SERVICE PROGRAM BULLETIN

APPLICABILITY: 2010 MY Subaru Legacy 2.5GT 6MT

NUMBERS: WTI-69

SUBJECT: WTI-69 Service Campaign - Vehicle Emission Control Information (VECI) Labels

Instructions for Customer Completion of Subaru Service Campaign WTI-69: Vehicle Emission Control Information (VECI) Label Replacement

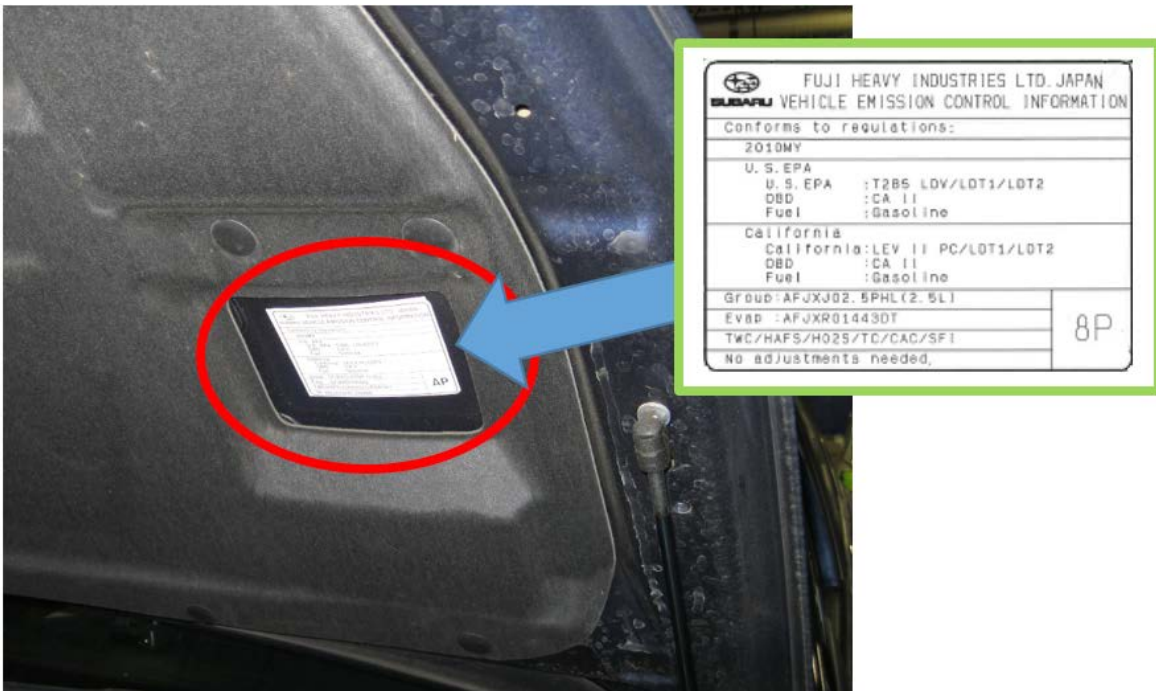
Step 3: Locate the existing VECI label on the driver’s side of the under hood panel as shown below.

Step 5: Peel the backing of the new **BLANK** label and apply it first, directly over the original. This will ensure the printing from the original label cannot be seen through the new label.

Step 7: Peel the backing of the new VECI label and apply it directly over the newly-installed blank label.
